STAFF REPORT
COMMUNITY DEVELOPMENT DEPARTMENT

HEARING DATE: April 5, 2022
 TO: Mayor & City Council
 FROM: Joseph Dodson, Associate Planner
 208-884-5533
 SUBJECT: H-2021-0096
 Aviation Subdivision

Preliminary Plat for 48 building lots (6 single family attached lots, 31 townhome lots, 2 detached single-family, and 9 multi-family lots), 8 common lots, and 1 other lot and a Conditional Use Permit for 36 multi-family units on 9 lots on 9.8 acres in the R-15 zoning district.

B. Preliminary Plat (dated: March 14, 2022)

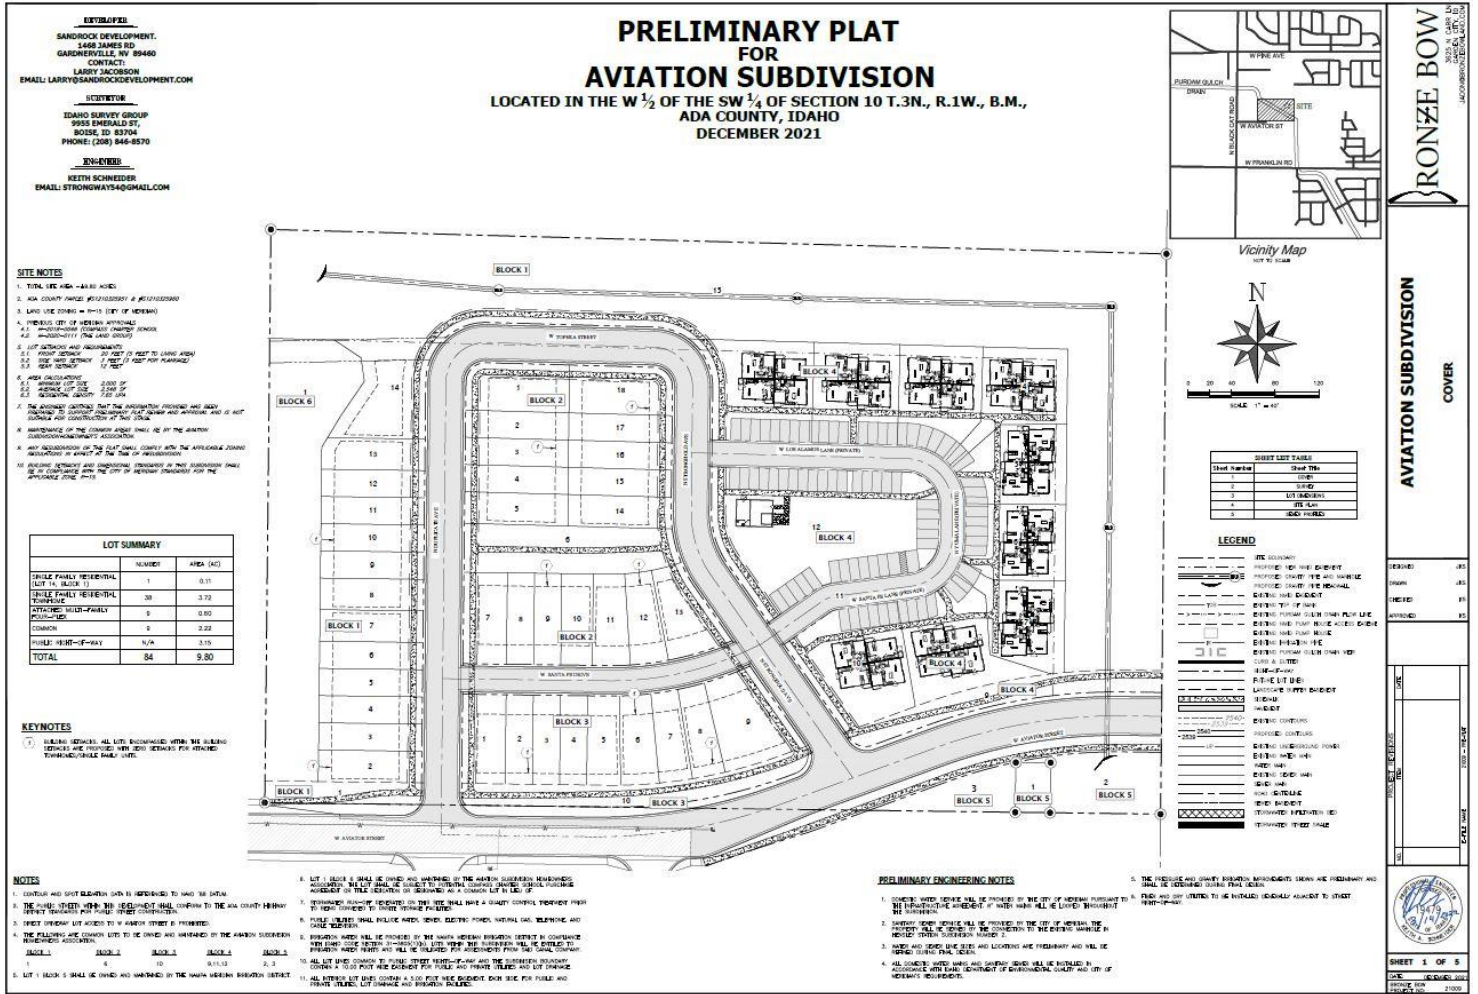
12. The submitted preliminary plat, dated ~~February~~ March 14, 2022, shall be revised as follows at ~~least 15 days~~ prior to the Final Plat submittal: ~~City Council hearing noted~~:

- a. ~~Revise the plat to include at least one (1) additional dwelling unit to meet the minimum density requirements of the Development Agreement and underlying future land use designation (MHDR).~~

- b. ~~Depict zero lot lines on the plat where single family attached and townhome structures are proposed.~~
 - c. ~~Show 5 foot wide detached sidewalks along both sides of the W. Aviator Street extension.~~

- ~~d. Revise the plat to show a reduction in the multi-family building lot sizes (Lots 1-7, Block 4) so that no more than 10 feet of the Purdam Gulch Drain easement is located on those lots, per UDC 11-3A-6, OR request a City Council waiver to allow more of the easement to encroach on the building lots if NMID allows it.~~

- ~~e. Add a plat note stating who is responsible for the maintenance of the Compass Charter School drain field located on Lot 1, Block 6.~~
13. The submitted landscape plan, dated December 2021, shall be revised prior to the first final plat submittal, ~~unless otherwise noted:~~

C. Landscape Plan (date: 8/03/2020 December 2021)

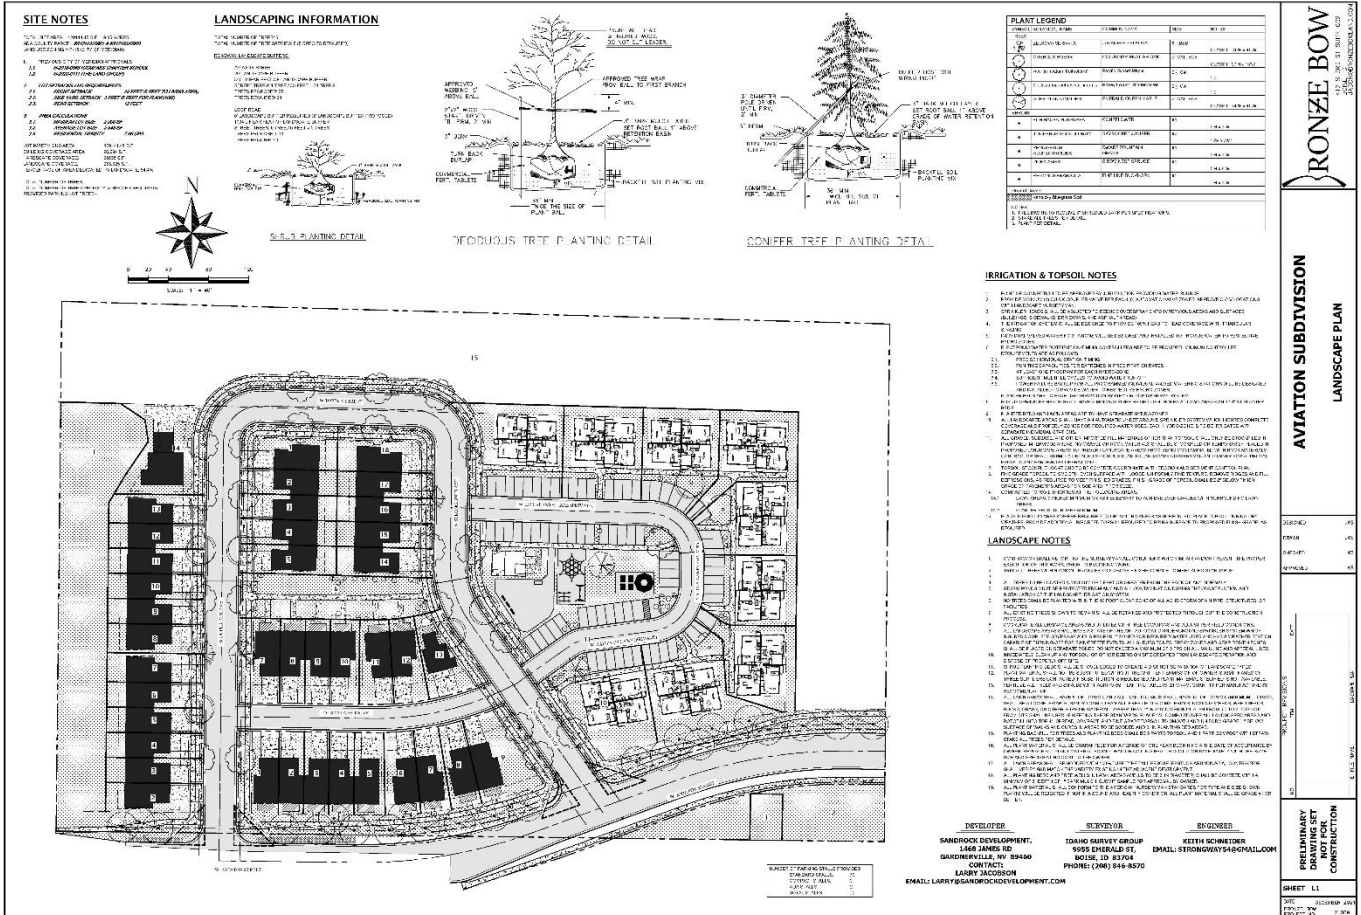
A 20-foot wide street buffer is required along the extension of W. Aviator Street (measured from back of curb), landscaped per the standards in UDC Table 11-3B-7C. A 20-foot wide common lot is shown on the north side of Aviator on the submitted plat in accord with UDC standards. The common lot along the south side of Aviator that is on the property is wider than 20 feet but is shown with an attached sidewalk instead of a detached sidewalk. Further, there are no trees shown on the south side of Aviator as required by the UDC. Per the plat condition noted, the Applicant should revise the landscape plan to show the required buffer trees on the south side of the Aviator extension.

According to the submitted landscape plan, some trees are included in the common open space areas due to the parkway trees along the local street. Staff is recommending an additional tree be placed in the center of the open space lot within the single-family portion of the project (Lot 6, Block 2) to add an area of shade in the center of this open space lot.

- a. Work with Nampa Meridian Irrigation District (NMID) to install a 5-foot wide pathway along the south and west side of the relocated Purdam Gulch Drain to further comply with open space and amenity standards; new pathway should provide a pathway stub to the east boundary and connect to the detached sidewalk along W. Aviator and the detached sidewalk along the internal local street near the north end of the site to create a looped walking path.

- ~~b. Add data to the landscape plans showing compliance with UDC 11-3B-7C for the proposed parkways.~~
 - c. Show the required street buffer trees within the required 20-foot buffer on the south side of the W. Aviator extension.

- d. Add an additional tree in the center of the open space lot within the single-family portion of the project (Lot 6, Block 2) to add an area of shade in the center of this open space lot.

- e. Add a picnic area or other amenity worth at least one (1) amenity point in the single-family portion of the project (Lot 6, Block 2) to comply with UDC 11-3G-3 amenity standards.

- f. Provide verification from NMID the common lot containing the piped and rerouted Purdam Drain can be vegetated with grasses; if it is not allowed, the Applicant should obtain a letter to that effect from NMID (should this area not be allowed to contain grasses, it may not qualify towards the open space calculation).

E. Conceptual Building Elevations and floor plans (dated: March 2022) (**NOT APPROVED**)

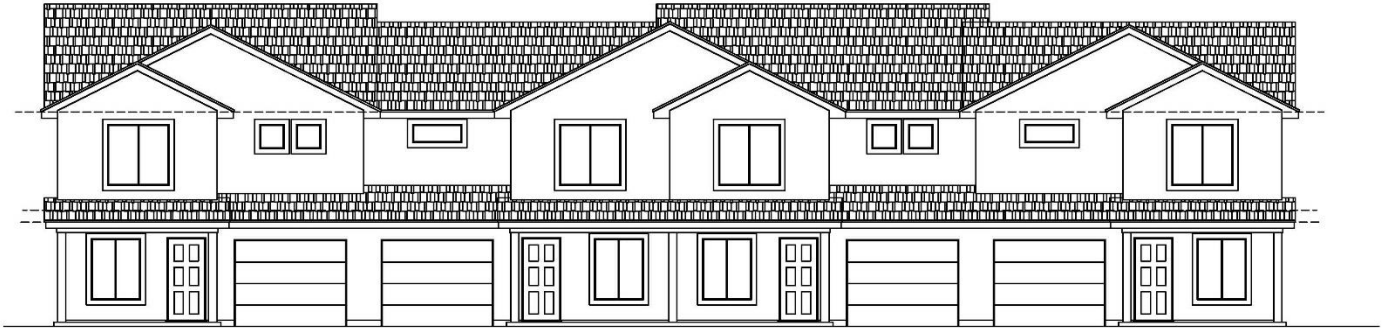
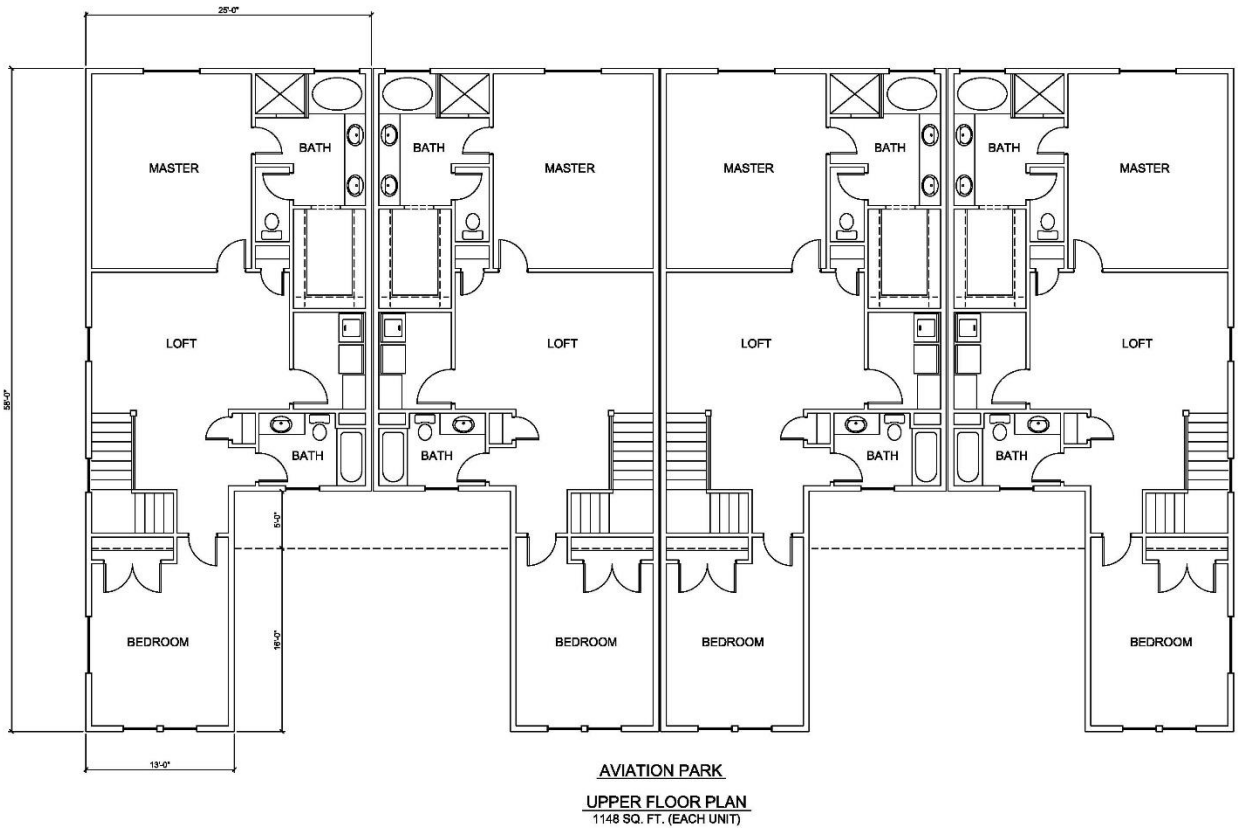
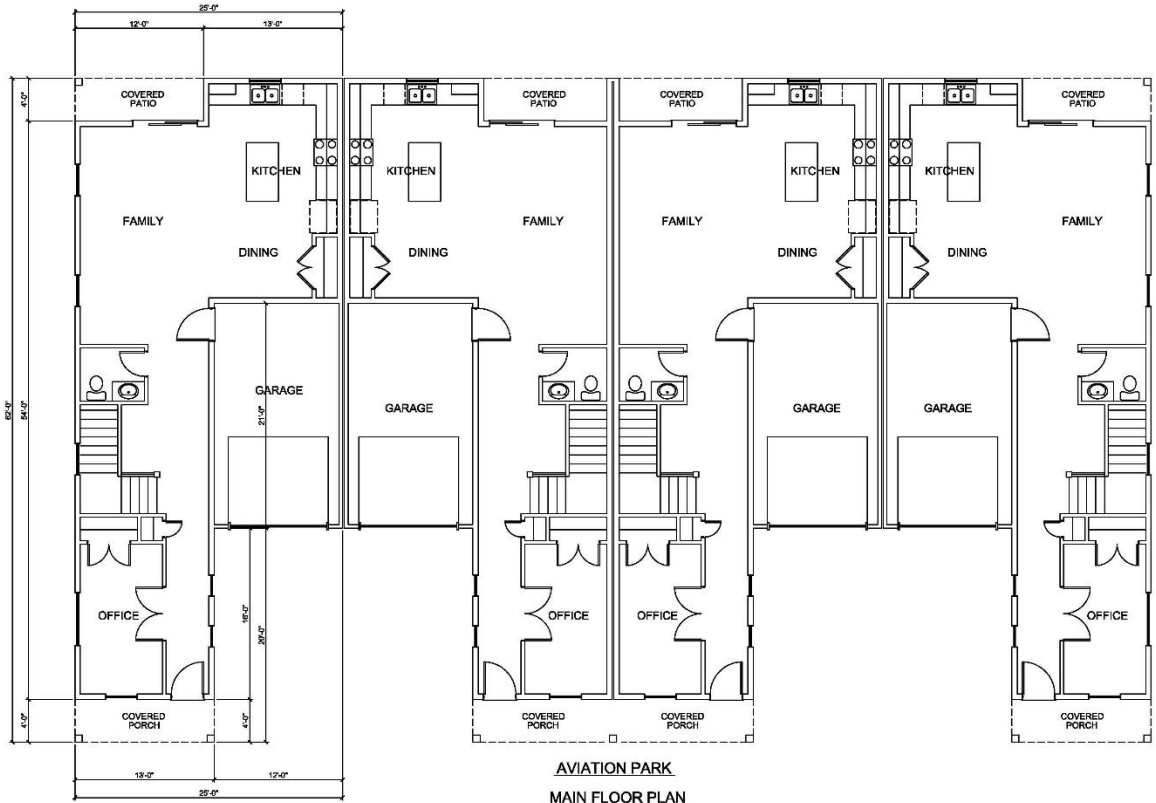
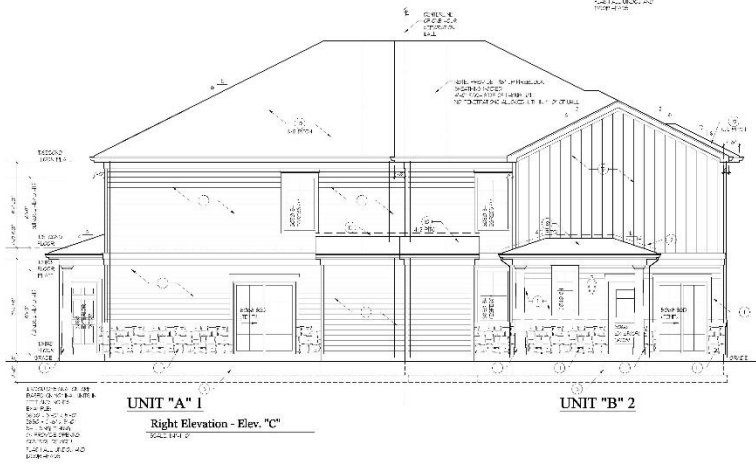
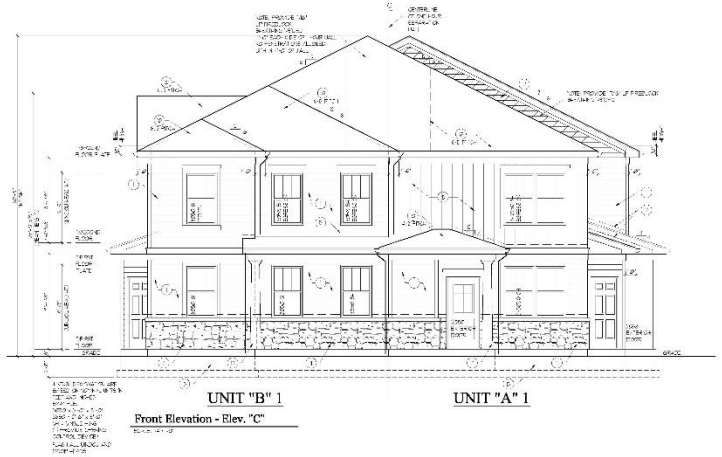
14. The submitted conceptual elevations for the townhome and single-family attached units are approved with the following standards to be maintained: ~~shall be revised as follows at least ten (10) days prior to the City Council hearing:~~

- a. Applicant shall comply with the design guidelines within the TMISAP.
 - ~~b. Explore alternate design options to be more consistent with the street oriented design standards within the Ten Mile Plan while maintaining a gross density of at least 8 units per acre; an alternate floor plan and revised elevations should be submitted in accord with this provision.~~

- c. ~~Revise the elevations to correspond~~ Ensure the street level and upper level architectural detailing ~~to unify is unified throughout~~ the design.

- ~~d. Provide additional modulation in wall plan and roof height variation.~~
 - e. Depict varying build-to lines for all of the front-loaded townhomes to ensure modulation in the building massing between and along sets of the townhome buildings.
